UNITED STATES PATENT AND TRADEMARK OFFICE

APPLICATION NO.	FILING DATE	FIRST NAMED INVENTOR	ATTORNEY DOCKET NO.	CONFIRMATION NO.
10/069,705	02/25/2002	Gerhard Rueckert	4299/PCT	3988
21553	7590	02/18/2005	EXAMINER	
FASSE PATENT ATTORNEYS, P.A. P.O. BOX 726 HAMPDEN, ME 04444-0726			HORTON, YVONNE MICHELE	
		ART UNIT		PAPER NUMBER
		3635

Office Action Summary	Application No.	Applicant(s)	
	10/069,705	RUECKERT, GERHARD	
	Examiner Yvonne M. Horton	Art Unit 3635

DETAILED ACTION

EXAMINER'S ATTACHMENT

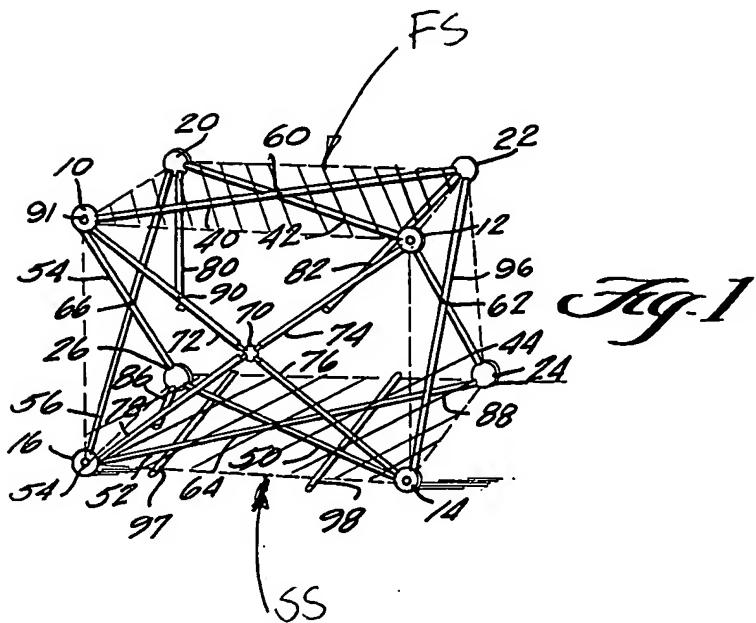
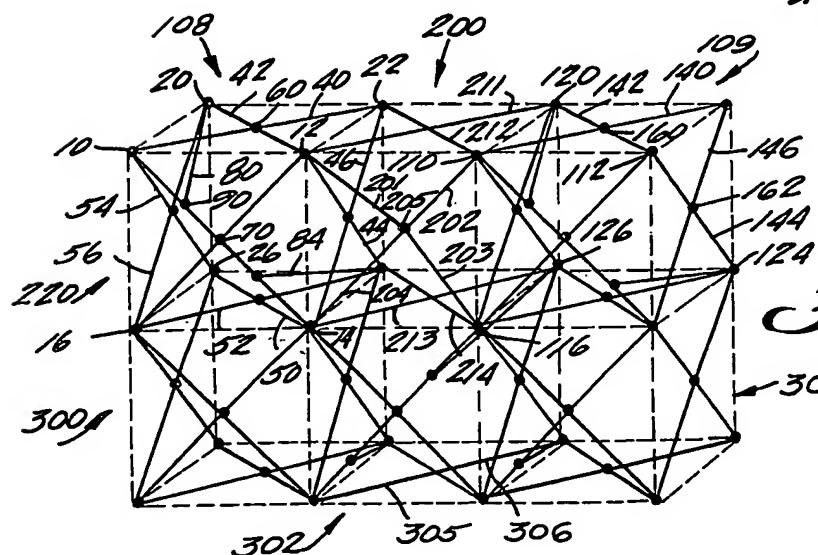
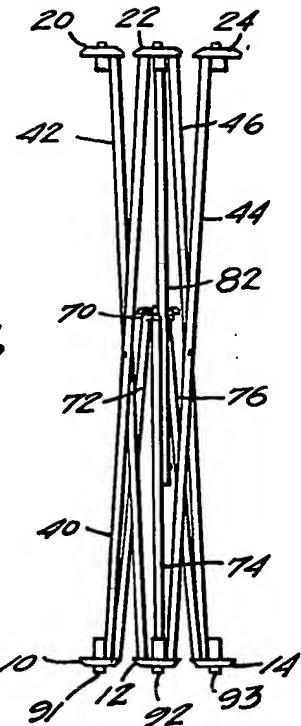
of a variable support structure with a modular construction consisting of at least one collapsible support structure module, which is bounded by joints (10,12,20,22) of a first joint set, which are corner joints of the support structure module and lie in a first surface (FS), and by joints (14,16,24,26) of a second joint set, which are corner joints of the support structure module and lie in a second surface (SS), and with at least one joint (70,82,90) of a third joint set, which lies outside of the first surface and not located at a corner, whereby at least a portion of the joints of the first and second joint set is constrained and fixable in its position relative to one another, especially connectable with one another, by a guide mechanism (60,62,64,66) including scissor arrangements (40,42); (44,46); (50,52); and (54,56), characterized in that, one joint (70) of the third joint set is connected with at least two joints (10,12) and (14,16) of the first and second joint set, respectively, by a connecting elements (72,74) and (76,78) and is arranged below a lowermost joint (10,12) among the joints of the first joint set (10,12,20,22).

Claims 42 and 43 are rejected under 35 U.S.C. 103(a) as being unpatentable over US Patent #4,471,548 to GOUDIE. GOUDIE discloses the use of a variable support structure with a modular construction consisting of at least one collapsible support structure module, which is bounded by joints (10,12,20,22) of a first joint set, which are corner joints of the support structure module and lie in a first surface (FS), and by joints (14,16,24,26) of a second joint set, which are corner joints of the support structure module and lie in a second surface (SS), and with at least one joint (70,82,90) of a third joint set, which lies outside of the first surface and not located at a corner, whereby at least a portion of the joints of the first and second joint set is constrained and fixable in its position relative to one another, especially connectable with one another, by a guide mechanism (60,62,64,66) including scissor arrangements (40,42); (44,46); (50,52); and (54,56), characterized in that, one joint (70) of the third joint set is connected with at least two joints (10,12) and (14,16) of the first and second joint set, respectively, by a connecting elements (72,74) and (76,78) and is arranged below a lowermost joint (10,12) among the joints of the first joint set (10,12,20,22). GOUDIE discloses the basic claimed structure except he does not specify that the connection elements are tension only. Although GOUDIE is silent in this regard, he does mention that his connection elements are rigid. Rigidity implies the ability to encounter tension forces. Hence, although GOUDIE does not detail that the connection elements are tension-only, it would have been obvious from one having ordinary skill in the art at the

time the invention was made that GOUDIE includes joint connections that transmits essentially only tension forces. A framework should only have enough rigidity to prevent it from being distorted or twisted, but enough rigidity that would allow it to stand and be contracted for storage. Thus, at certain intervals during applied forces each element carries tension forces. The use intended for the structure would dictate or govern if any or all of the connection members would have the ability to be tension-only connections. The connection members determine the load distribution points and depending upon where and how the loads are required or needed to be carried or compromised would determine where, if anywhere, tension-only members would be disposed. Regarding claim 43, at least joints (10,14) include at least one of said first joints (10) and at least one of the second joints (14).
